## ADDENDUM #2

To: Known Qualified Firms  
From: Porter Co. Dept. of Development & Storm Water Management  
Date: March 26, 2021  
Subject: Sunnybrooke Subdivision – Storm Water Management System Improvements  
Construction Services

PROFILE VIEW OF SUNNYBROOKE SUBD. SWM SYSTEM IMPROVEMENTS

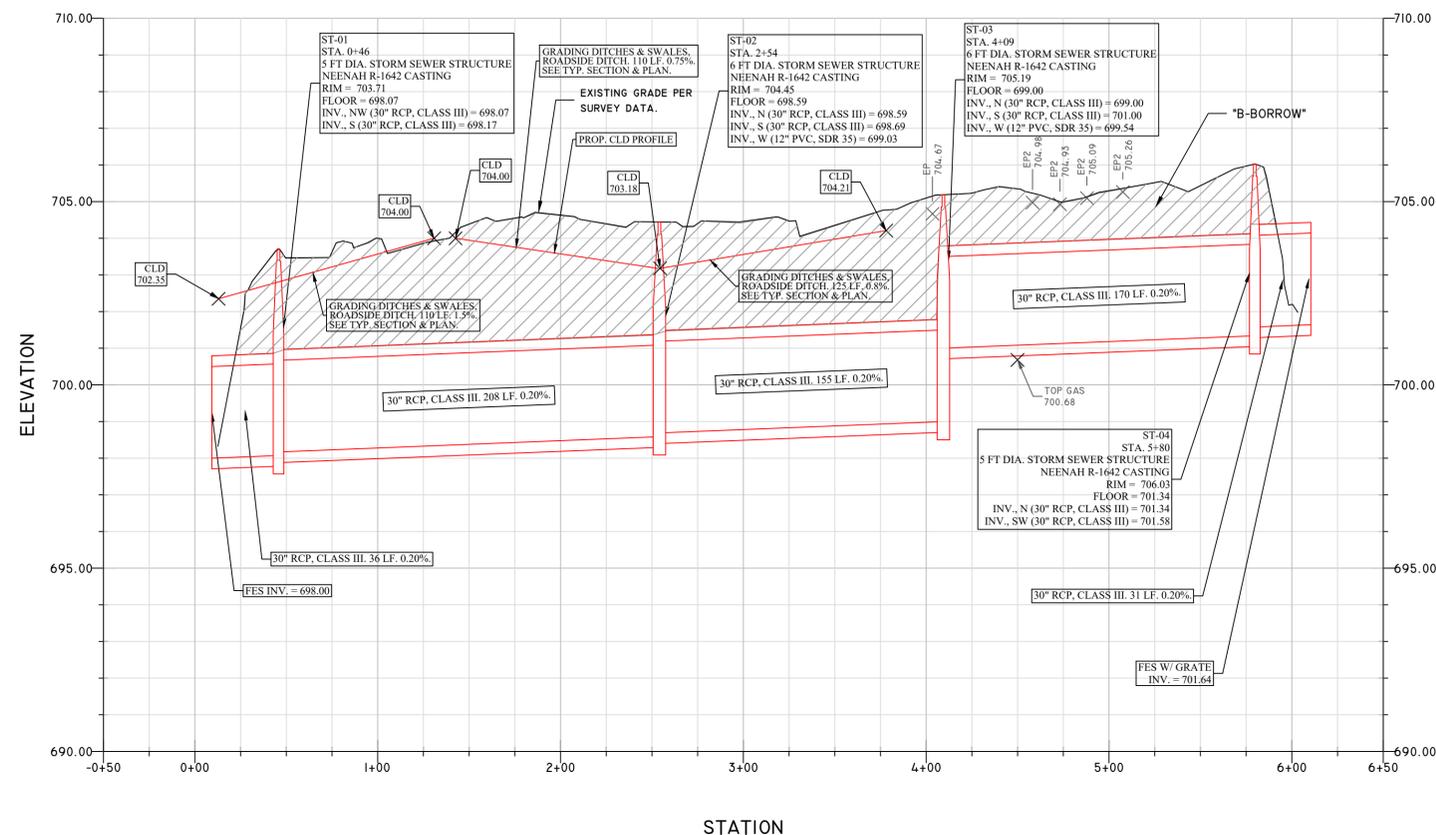
As a result of the location of the 2" steel gas main, the elevation of the proposed storm sewer invert has been adjusted upward between storm sewer structures ST-03 and ST-04 to allow for the storm sewer to be installed above, and out of conflict with, the gas main (see Items #3 & #4 below).

4. Storm Sewer between ST-03 and ST-04

**The construction plans have been revised** to account for the adjustment of the elevation of the proposed storm sewer invert between storm sewer structures ST-03 and ST-04. Such adjustment has been made to allow for the storm sewer to be installed above, and out of conflict with, the existing 2" gas main crossing CR 400 E along the south side of CR 1050 N.

PROJECT:	SUNNYBROOKE SUBD. -SWM SYSTEM IMPROVEMENTS
LOCATION:	NEAR CR 400 E & CR 1050 N
SHEET TITLE:	SHEET 6-TRAFFIC CONTROL PLAN

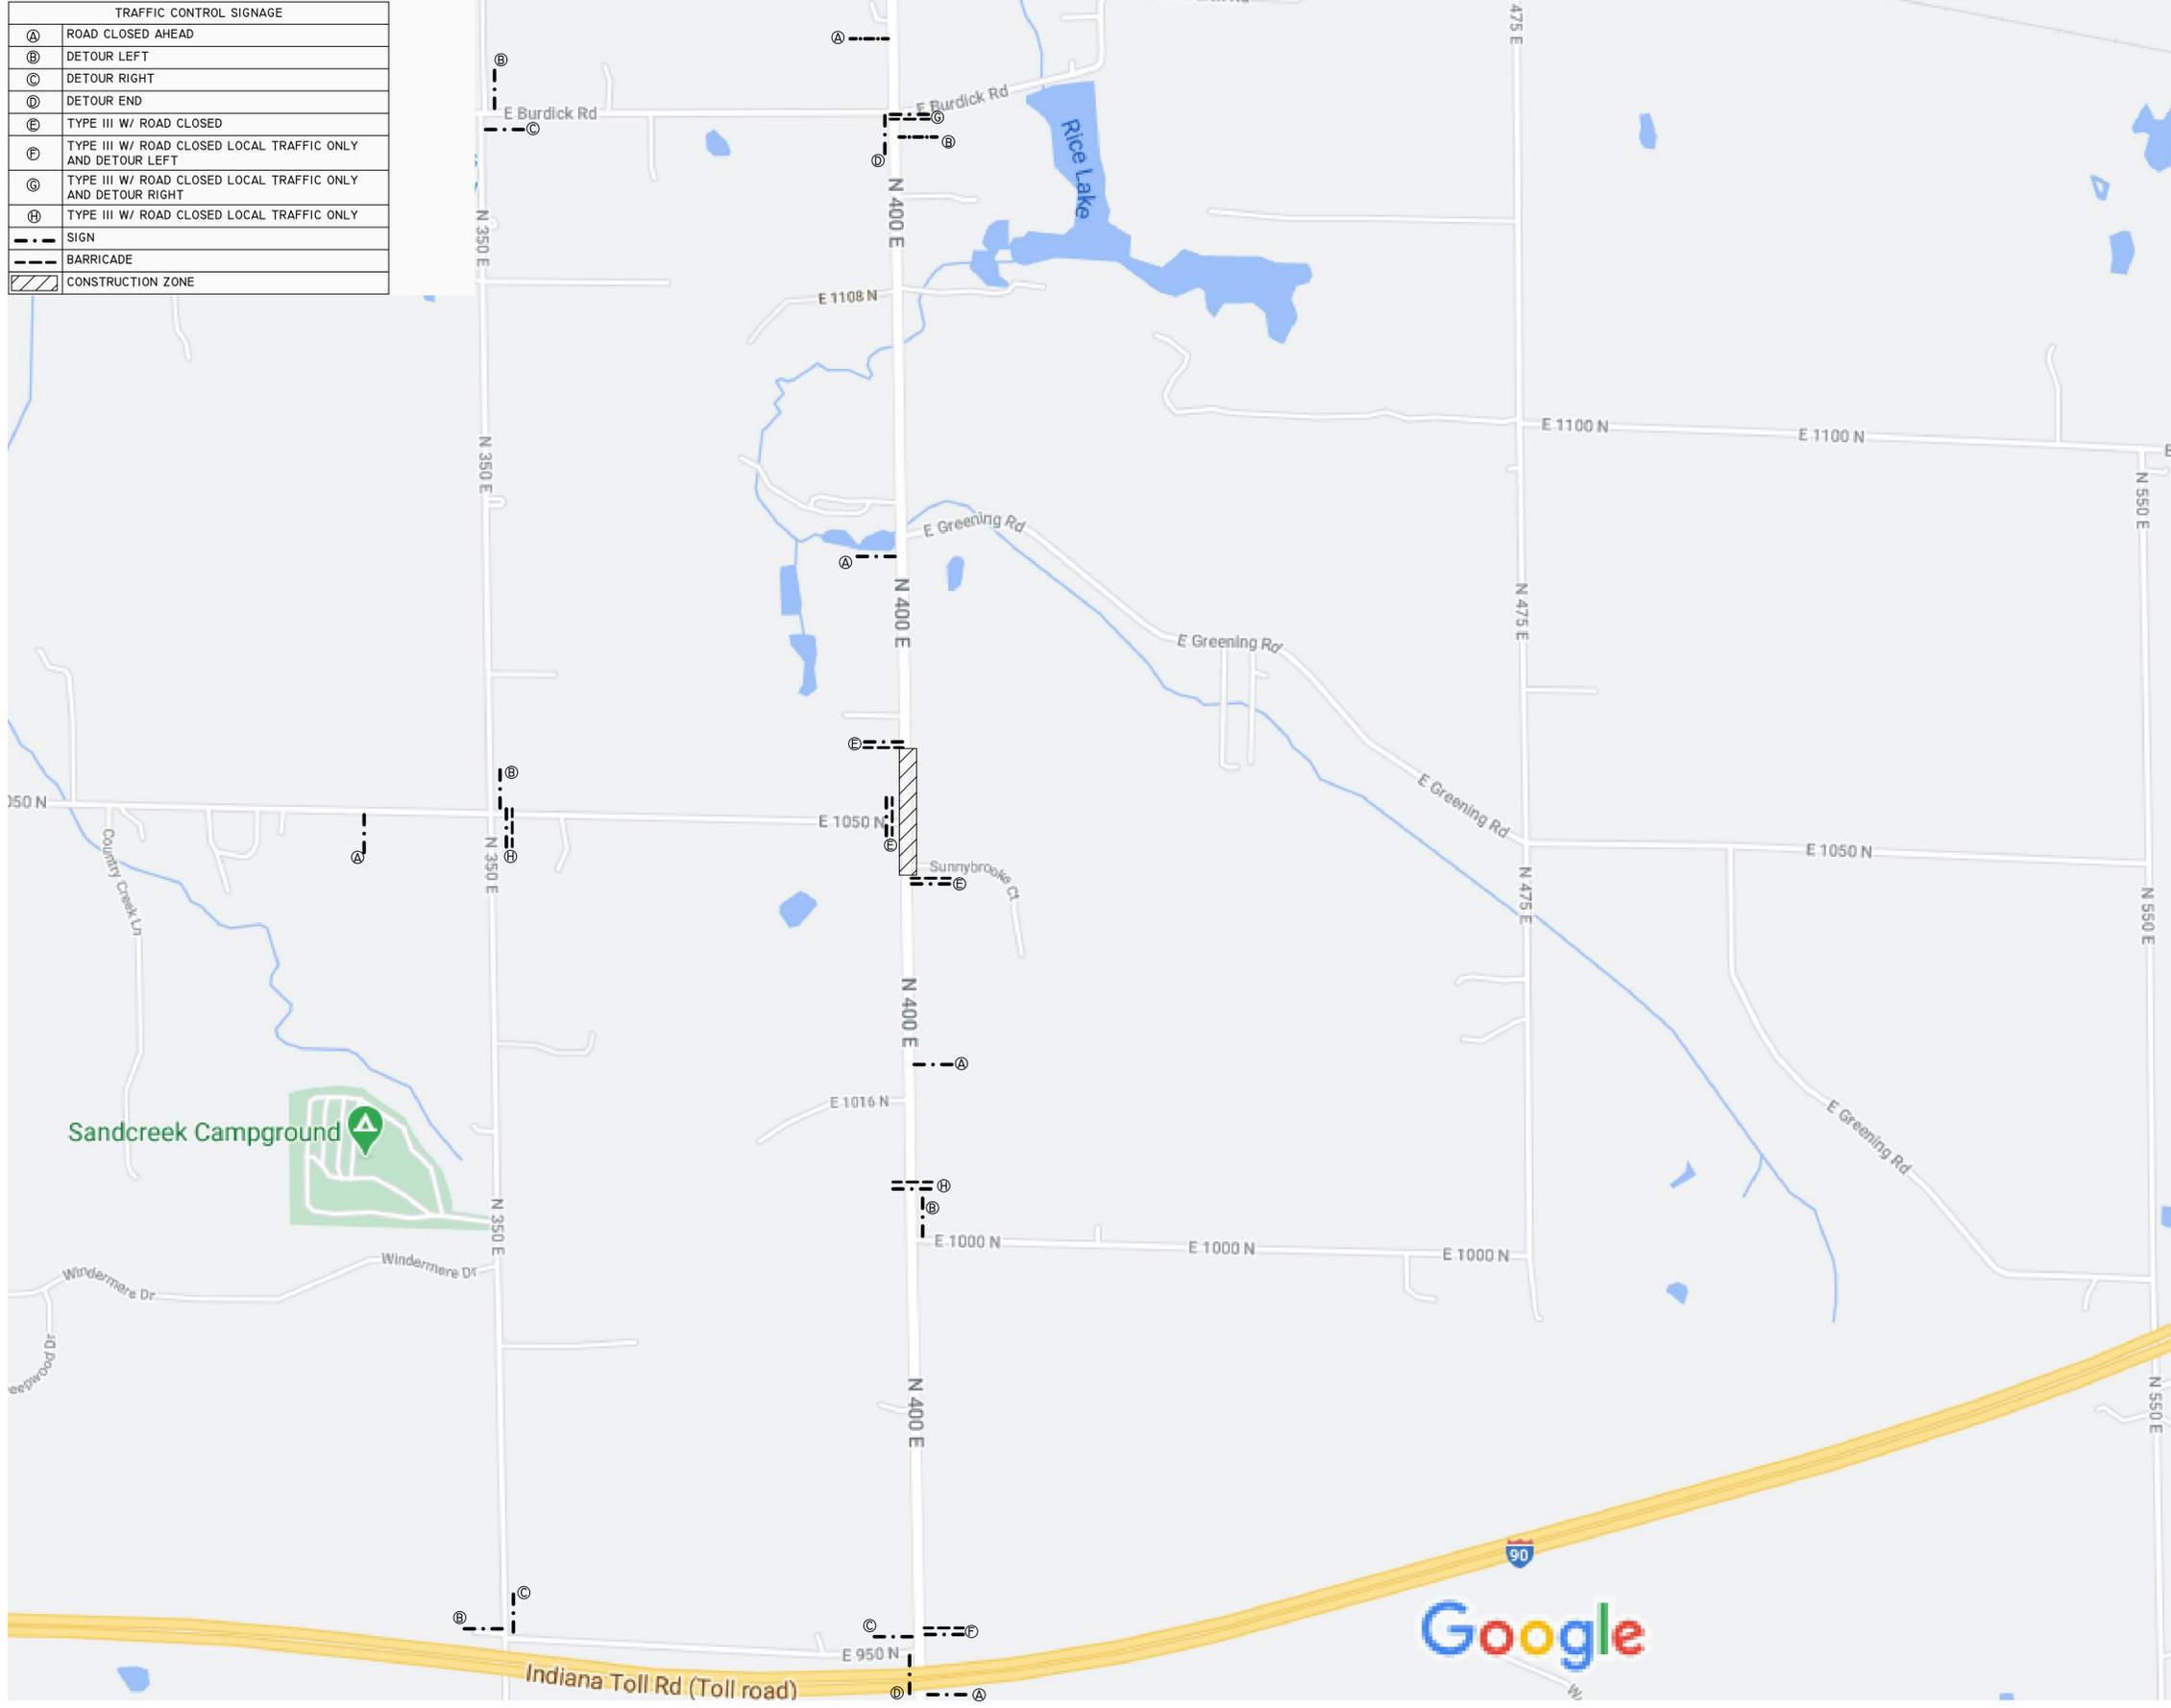
Q1: Can a full road closure be implemented? If so, is a detour plan available?

A1: Yes, a full road closure has been planned for this project. A detour plan is included on Sheet 6 of the construction plans.
